Item Name: Crosstube Turning Detail

Draw Nbr	Revision Nbr
D407-667-145	Rev C

DESIGN	90	DART AEROSPACE LTD	
DRAWN	RF	HAWKESBURY, ONTARIO, CANADA	
CHECKED	90	DRAWING NO.	REV. C
MFG. APPR.	90	D407-667-145	SHEET 4 OF 4
APPROVED	90	TITLE	SCALE
DE APPR.	90	CROSSTUBE ASSY (407 HIGH FWD)	NT
DATE	08.11.06	COPYRIGHT © 2002 BY DART AEROSPACE LTD	
THIS DOCUMENT IS PRIVATE AND CONFIDENTIAL AND IS SUPPLIED ON THE EXPRESS CONDITION THAT IT IS NOT TO BE USED FOR ANY PURPOSE OR COMMUNICATED TO ANY OTHER PERSON WITHOUT WRITTEN PERMISSION FROM DART AEROSPACE LTD.

DRAWING NO. D407-667-145	TITLE CROSSTUBE ASS'Y (407 HIGH FWD)	REV. C	DART AEROSPACE LTD ENGINEERING ORDER		D.E.O. NO. D407-667-145-C-1	SHEET NO. SHEET 1 OF 1	SCALE NTS
DRAWN <i>q</i>	CHECKED <i>ASS</i>	MFG. APPR. <i>IS</i>	APPROVED <i>WD</i>		DE APPR. <i>HA</i>		
DATE 11.07.15	DATE 11.07.22	DATE 11.07.22	DATE 11/07/22		DATE 11.07.21

C TURNING DETAIL

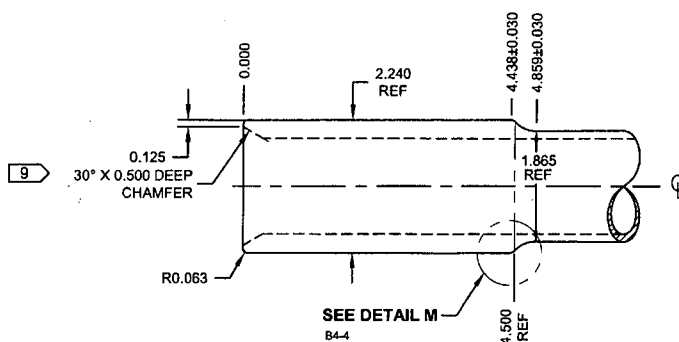
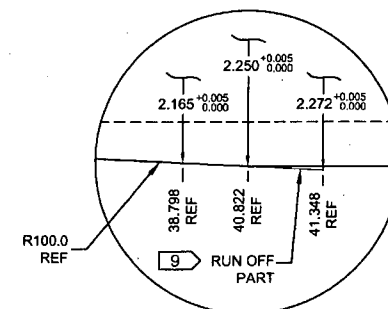
C	REVISE GENERAL NOTES/PART LIST (ZN D7-1); REORGANIZED VIEWS AND REFORMATTED DRAWING TO CURRENT STANDARDS. D3595-063-395 WAS D2856-400-694 (ZN D6-2 & A5-2); REMOVED REF. 7 ADD TOLERANCES (ZN C6-3, C4-3, D2-3); RELOCATED FLAG #6 (ZN A8-3) PER NCR 210; MOVED TURNING DETAIL & UPDATED TOLERANCE TO SHEET 4.	RF	08.11.06
B	ADD HOLES AND NUT PLATES FOR COMPATABILITY WITH BHT/AA SKUDTUBES	PH	05.07.26
A	NEW ISSUE	CP	02.05.08
REV.	DESCRIPTION	BY	DATE
DESIGN	RF	DART AEROSPACE LTD HAWKESBURY, ONTARIO, CANADA	
DRAWN	RF	DRAWING NO.	REV. C
CHECKED	RF	D407-667-145	SHEET 1 OF 4
MFG. APPR.	RF	TITLE	SCALE
APPROVED	RF	CROSSTUBE ASS'Y (407 HIGH FWD)	NTS
DE APPR.	RF	COPYRIGHT © 2002 BY DART AEROSPACE LTD THIS DOCUMENT IS PRIVATE AND CONFIDENTIAL AND IS SUPPLIED ON THE EXPRESSED CONDITION THAT IT IS NOT TO BE USED FOR ANY PURPOSE OR COPIED OR REPRODUCED TO ANY OTHER PERSON WITHOUT WRITTEN PERMISSION FROM DART AEROSPACE LTD.

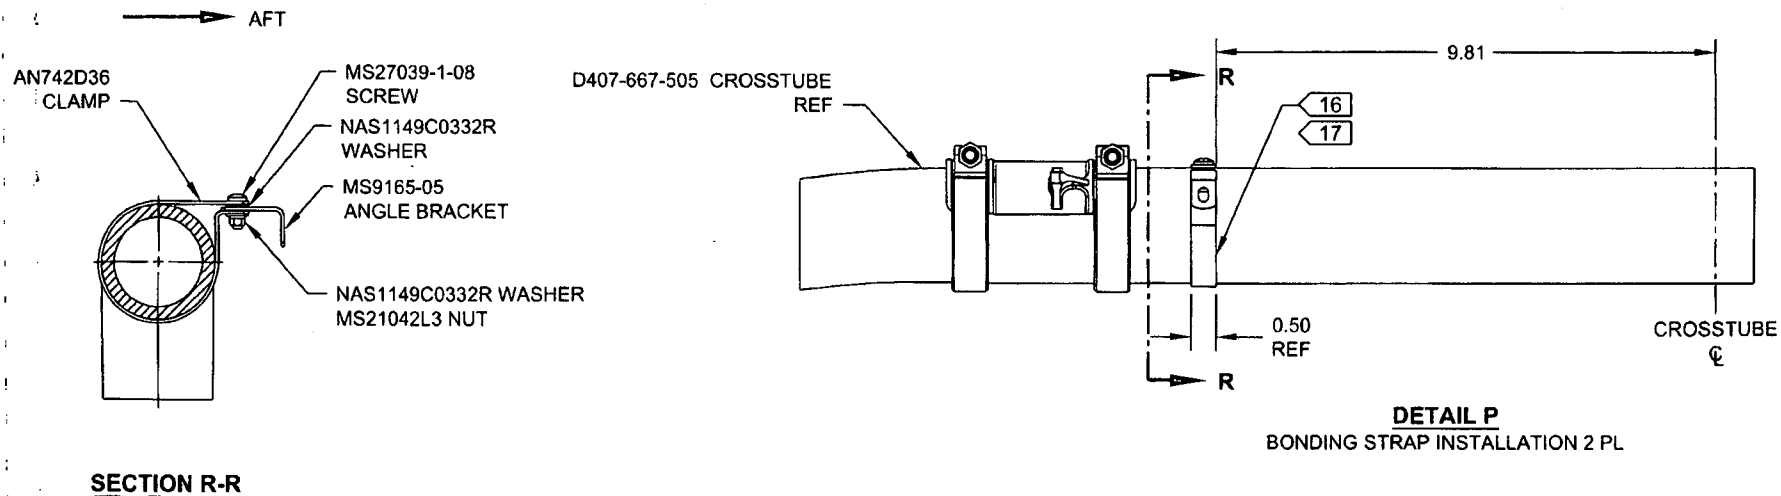
ADD ELECTRICAL GROUNDING STRAP

ITEM	QTY -145	PART NUMBER	DESCRIPTION
1	X	D407-667-145	CROSSTUBE ASSEMBLY (407 HIGH FWD)

10	2	AN742D36	CLAMP
11	2	MS9165-05	ANGLE BRACKET
12	2	MS21042L3	NUT (OR MS21042-3)
13	2	MS27039-1-08	SCREW
14	4	NAS1149C0332R	WASHER (OR AN960C10L)

- 16) MASK AREA UNDER CLAMP PRIOR TO PAINTING
- 17) SEAL EDGES WHERE AN742D36 CLAMP MEETS WITH THE CROSSTUBE USING SIKAFLEX-241/-291 OR MIL-S-8802 CLASS B2 OR PROSEAL 890 SEALANT
- 18) PERFORM RESISTANCE CHECK TO ENSURE MAX RESISTANCE IS 10 MILLIOHMS
